**DOCUMENT 00 90 00  
ADDENDUM**

**ADDENDUM NO. [3]                      Date: November 20, 2018**

**RE:                      GLENWOOD COMMUNITY SCHOOL DISTRICT  
ATHLETIC COMPLEX IMPROVEMENTS BID PACKAGE 2 REBID  
400 SIVERS ROAD  
GLENWOOD, IOWA 51534  
HSR PROJECT NO. 18005**

Sheet Title:  
**SITE LAYOUT PLAN (ATHLETIC SITE)-BID PACKAGE #2**

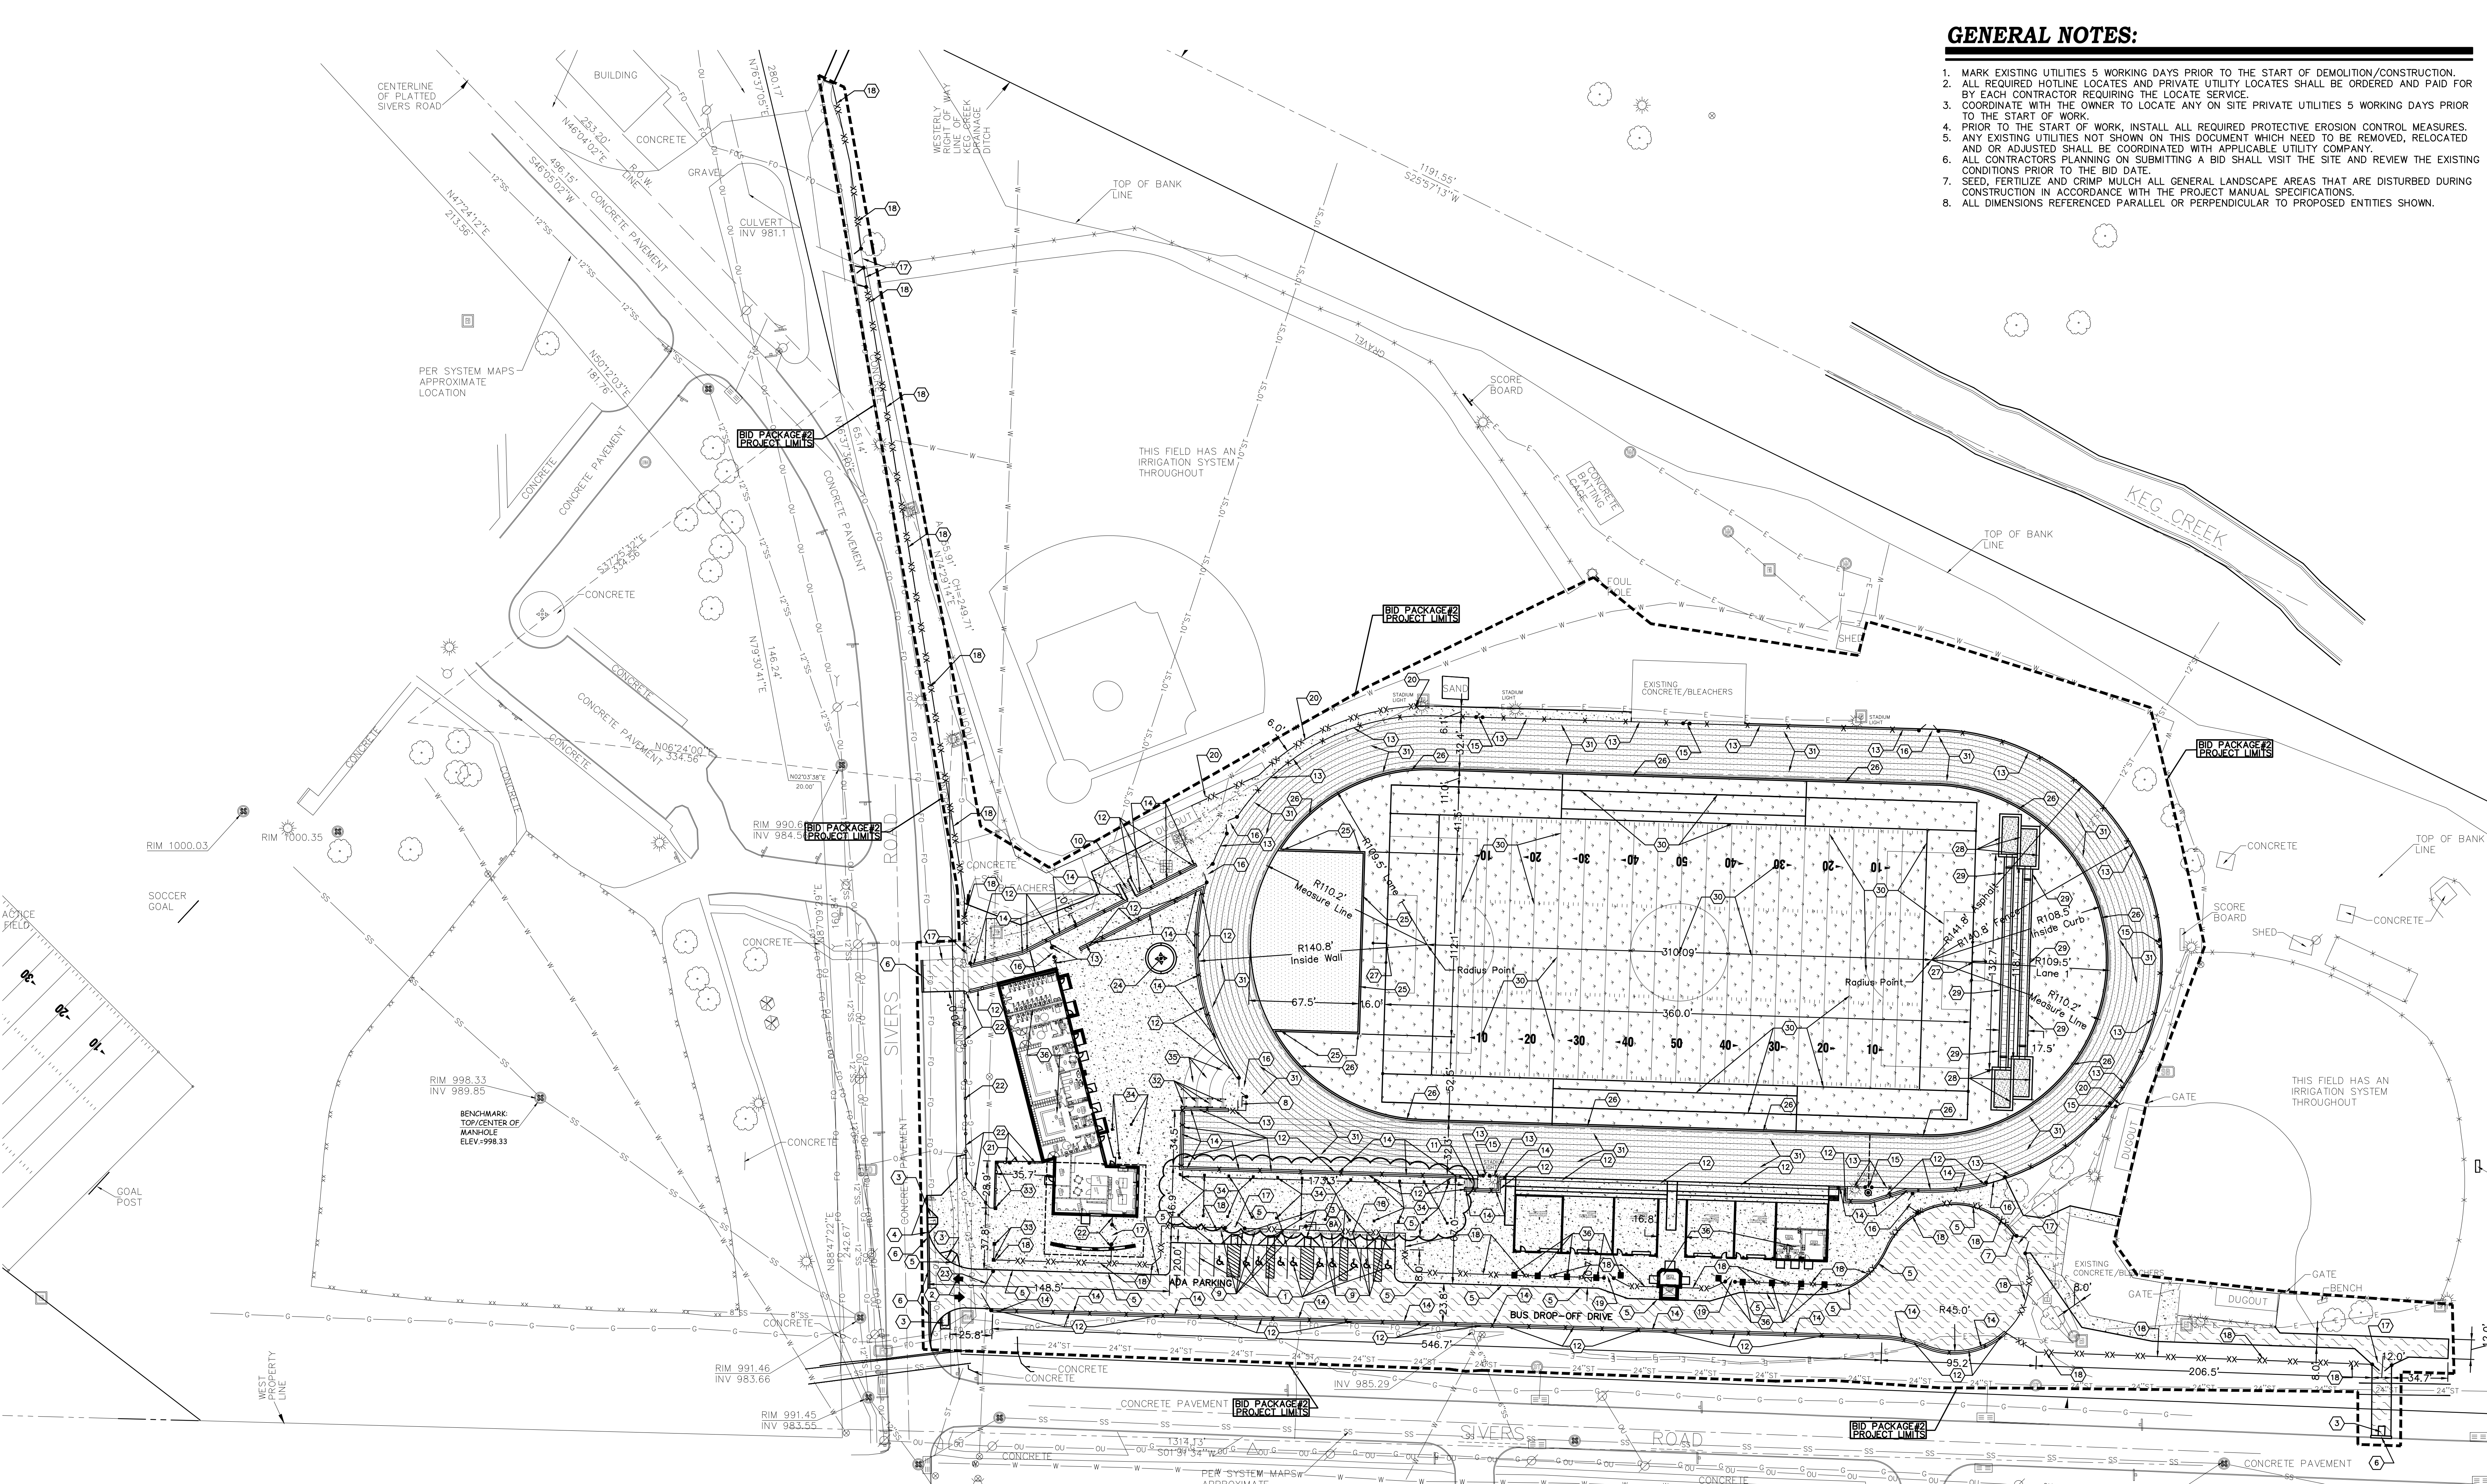
9. Sheet C102R SITE LAYOUT PLAN (ATHLETIC SITE) BID PACKAGE #2 30 x 42 Drawing attached hereto

- a. Revisions clouded on Drawing.
- b. Install (24) additional concrete tent tie downs at south end of proposed Gateway building adjacent to running track retaining wall.
- c. Note 26 indicates required curb for slot drain at alternate bid only. Slot drain not required for artificial turf system.

GLENWOOD COMMUNITY SCHOOL DISTRICT  
ATHLETIC COMPLEX IMPROVEMENTS-BID PACKAGE #2  
SITE UTILITY PLAN (ATHLETIC SITE)-BID PACKAGE #2

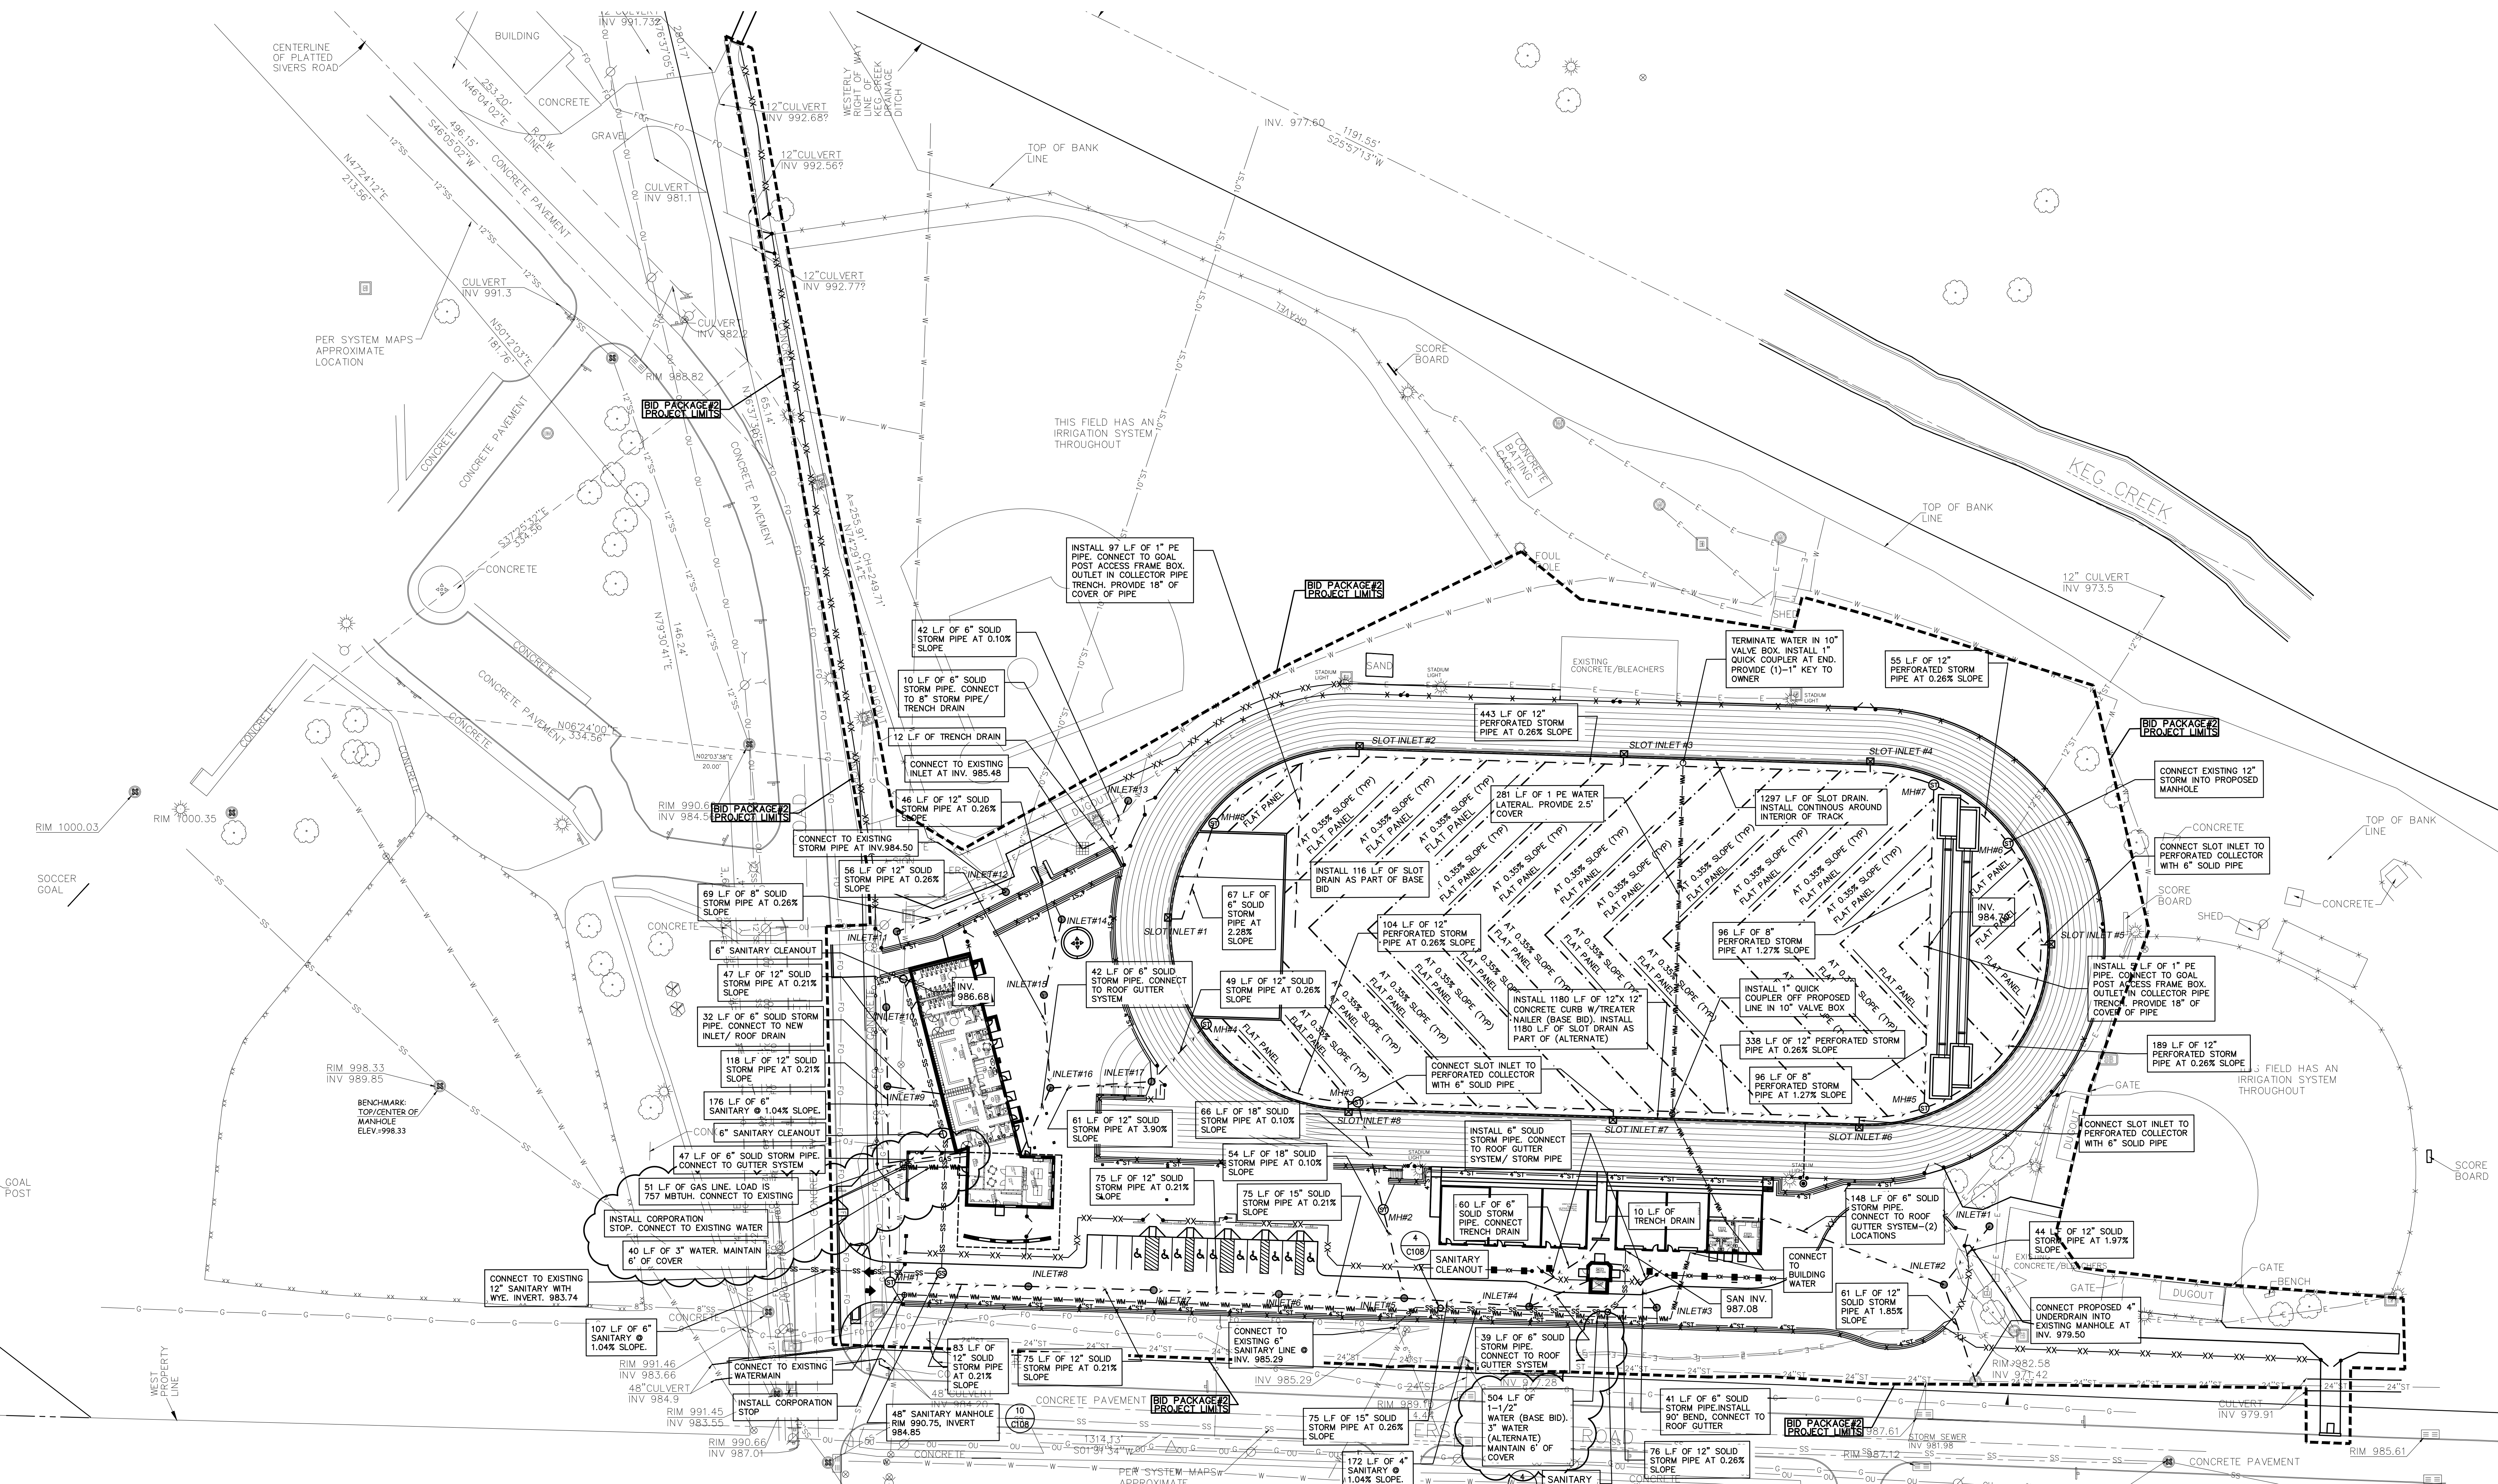
10. Sheet C105R SITE UTILITY PLAN 30 x 42 Drawing attached hereto

- a. Revisions clouded on Drawing.
- b. New water service installed up to the northwest corner of proposed Gateway building shall be 3" in lieu of 2".
- c. Install 51 L.F of new gas service (load 757 MBTUH) to the northwest corner of proposed Gateway building.
- d. Install 504 L.F of new 1 ½" water service from existing water main located at north end of proposed bus drive up to the new concessions building located under stadium bleachers (Base bid). Install 504 L.F of new 3" water service in lieu of 1 ½" water service as part of (Alternate Bid).
